# Cleveland City Planning Commission

Friday, March 31, 2023

**DF2022-070** – Mazzella Lifting Technologies Signage Expansion: Seeking Final Approval

## DF2023-004 – Rock & Roll Hall of Fame Expansion: Seeking Conceptual Design

# Proposed Site Plan

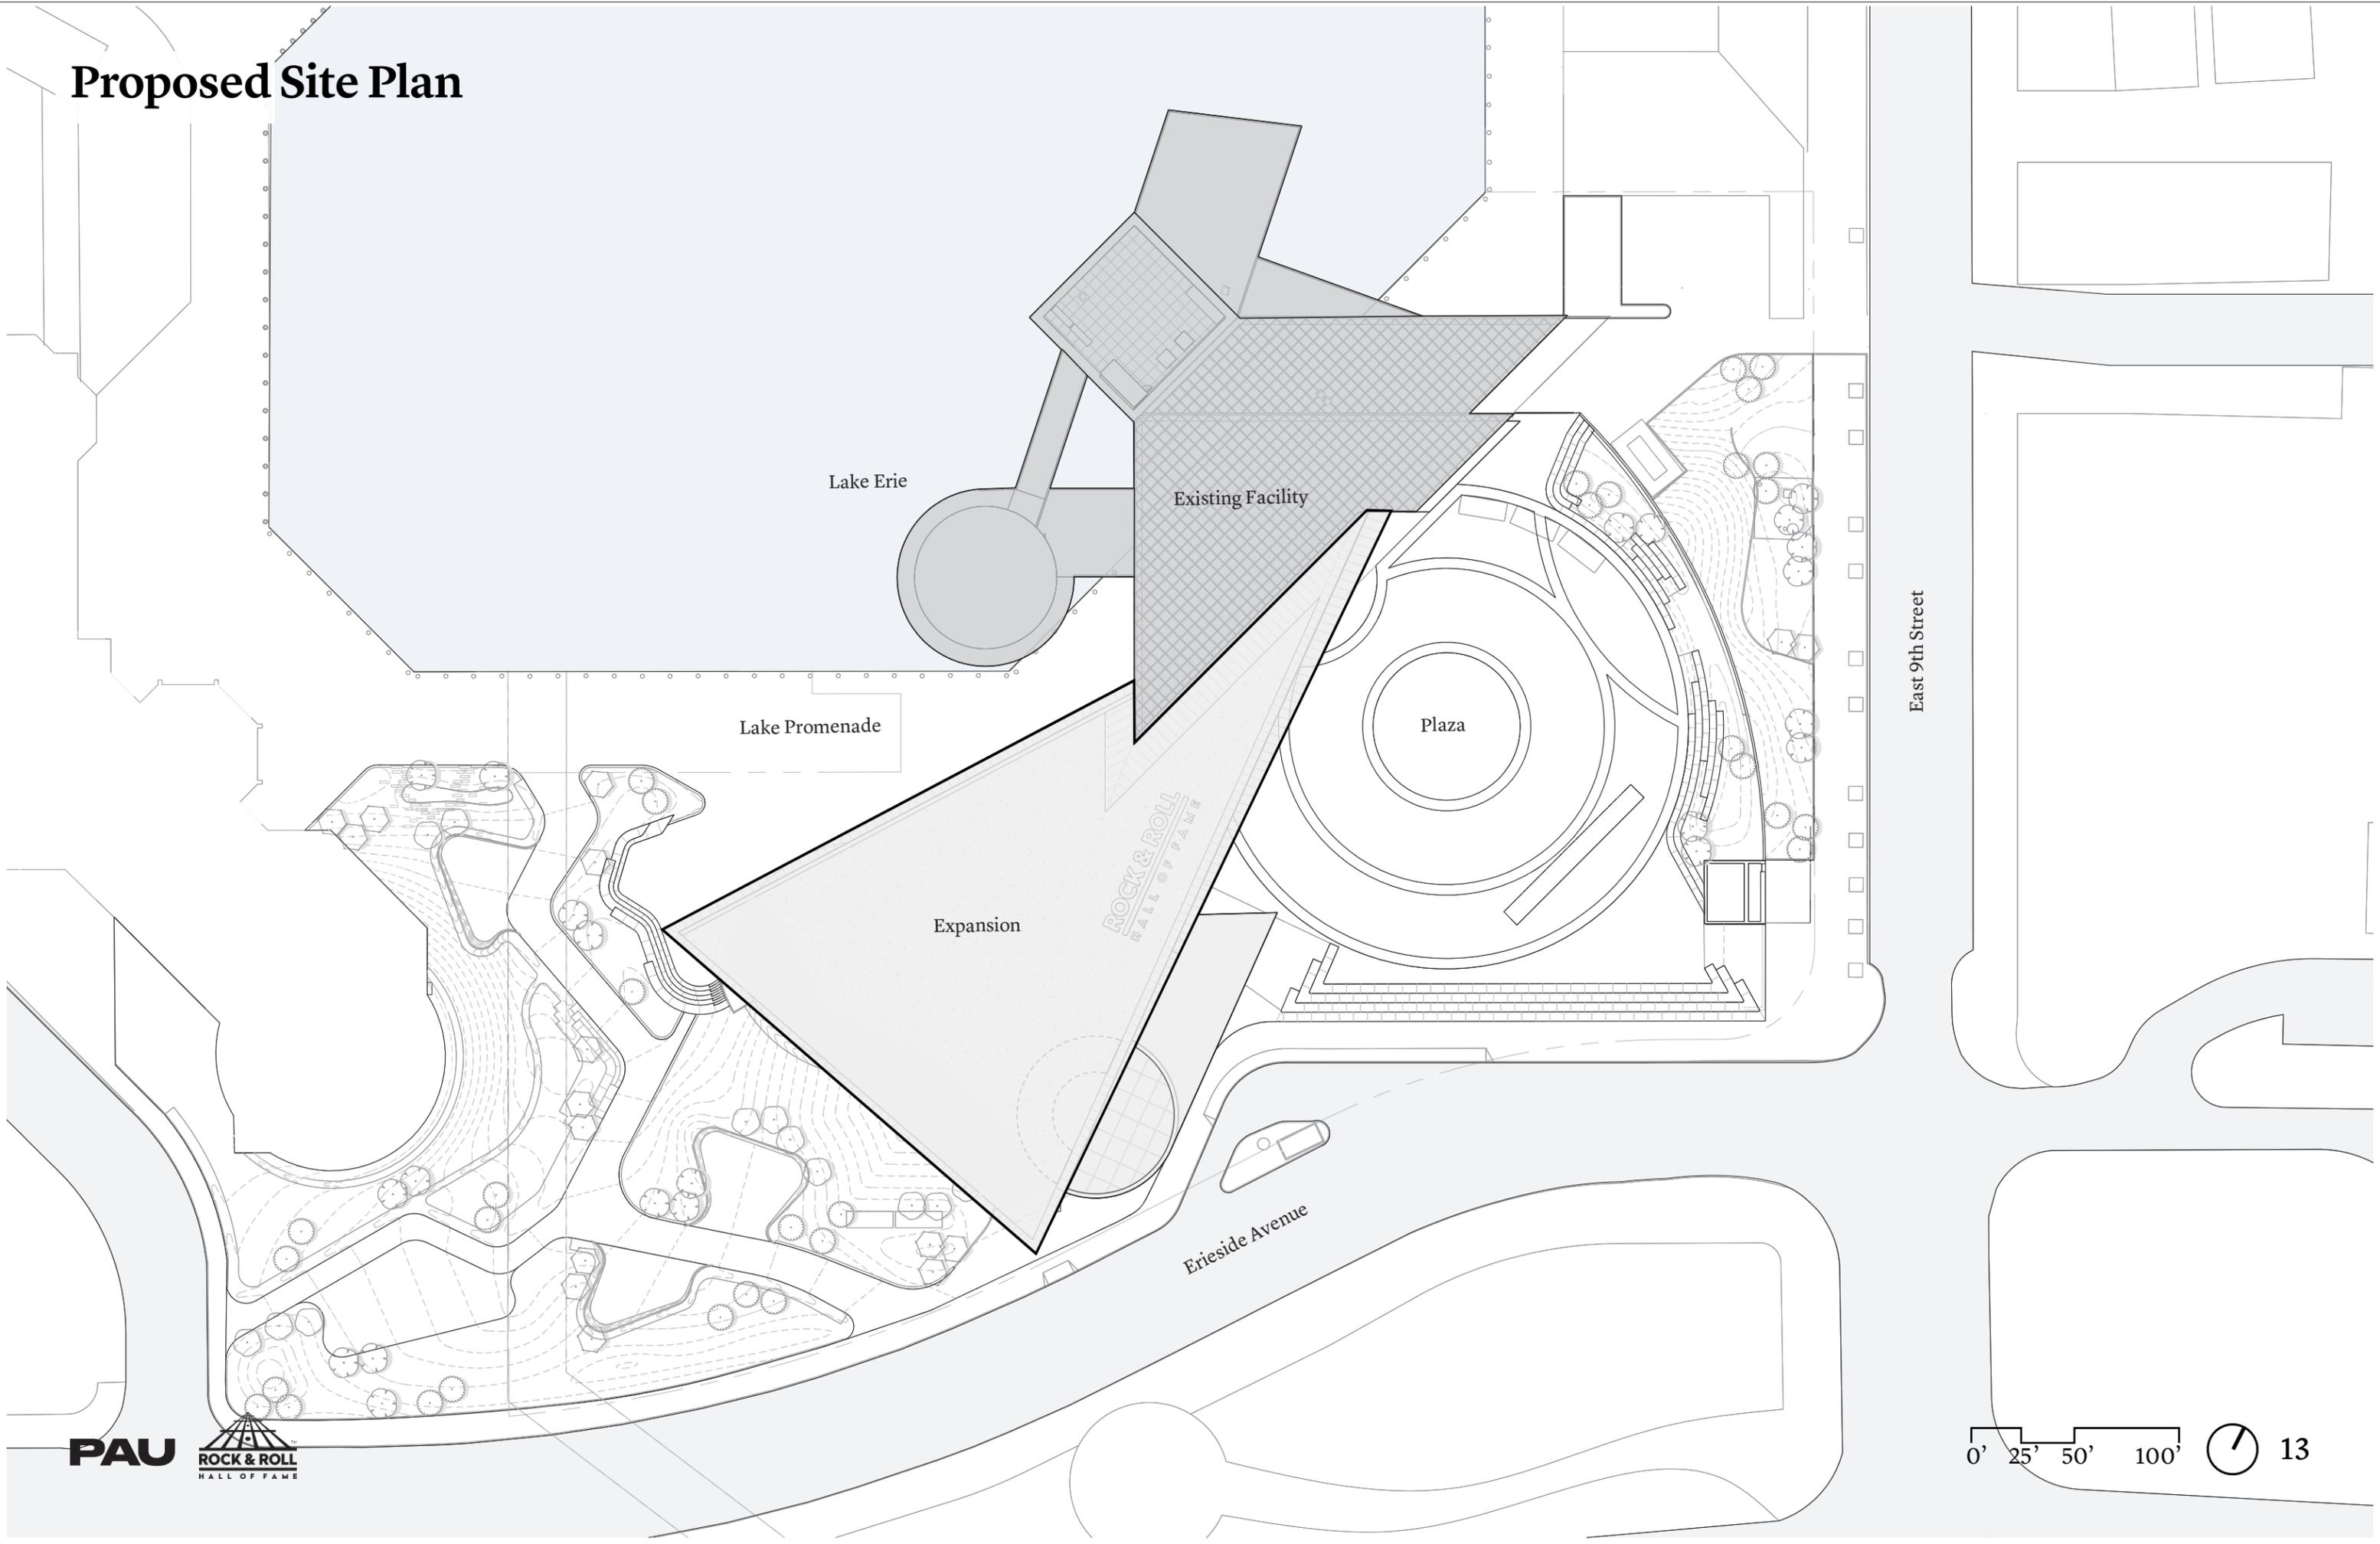
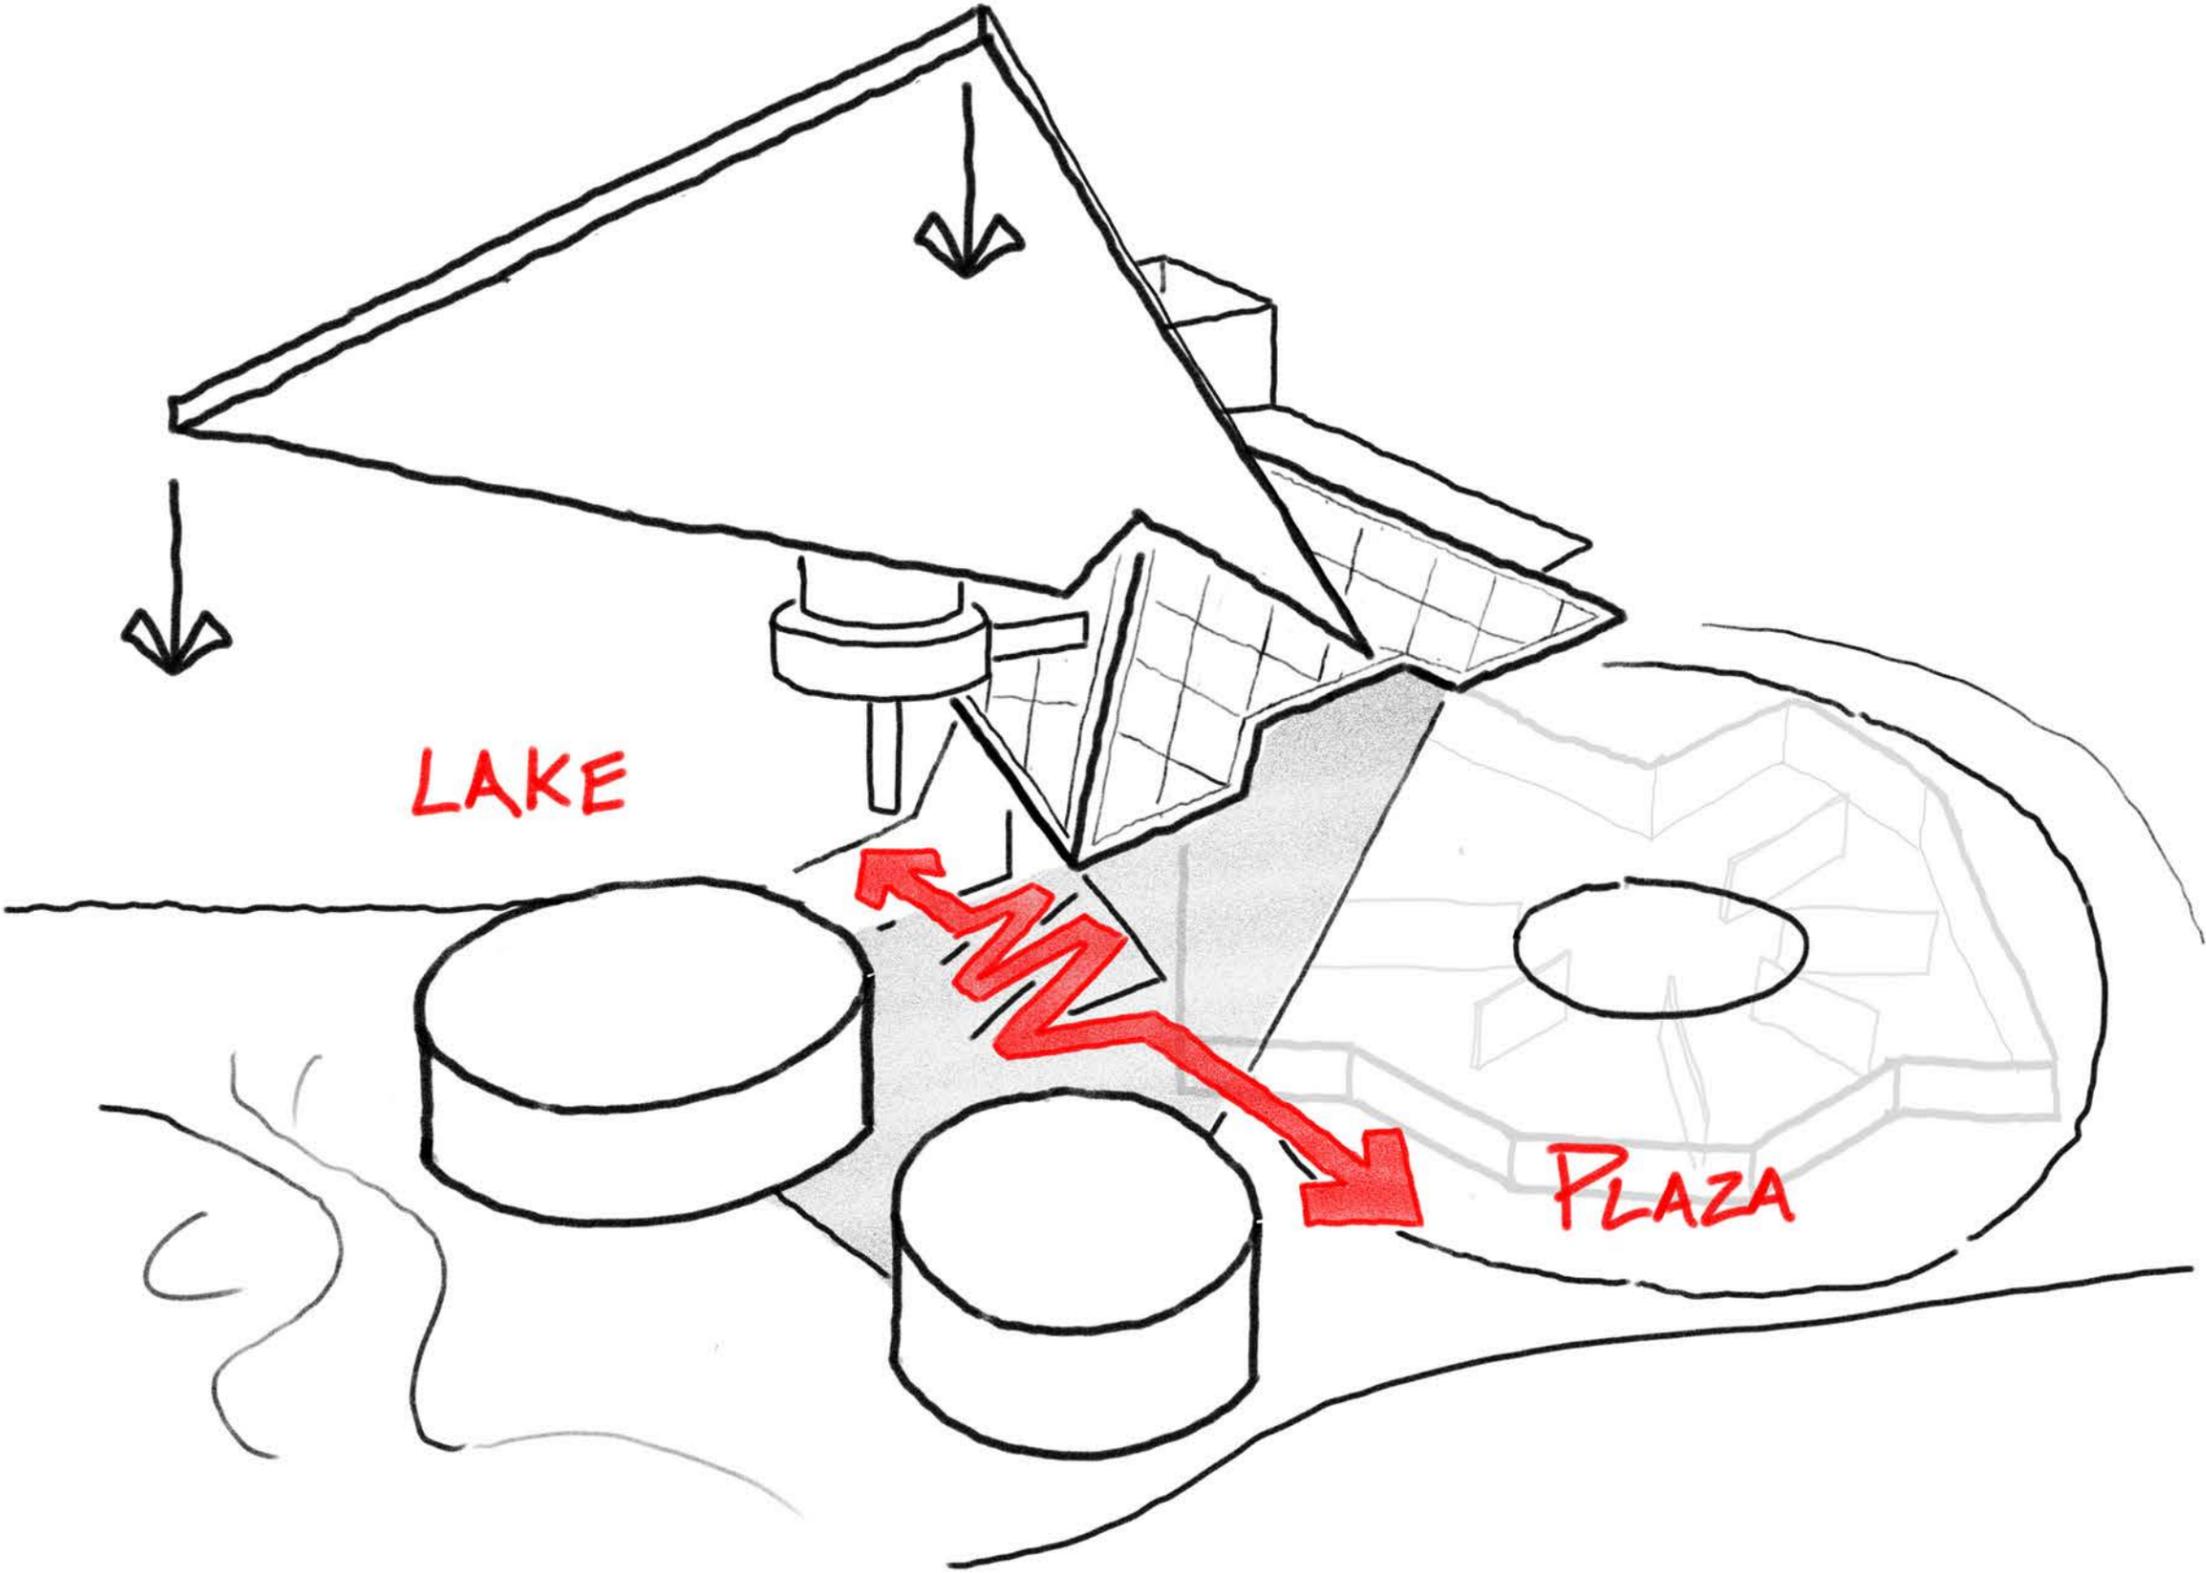
### Committee Recommendation: Approved with **Comments**

- Provide signage and wayfinding to the lakefront and surrounding downtown assets
- Create passive programming and public engagement opportunities along the proposed greenspace and at existing plaza
- Need to study the intersection between the new and existing architecture, and intersection of roof elements with walls; details are important to for longevity of the building and avoiding maintenance issues
- Reconsider the design of the entry element to better define the entry itself
- Reconsider the relationship between the iconic geometry of the architecture and proposed geometry of the path/landscape
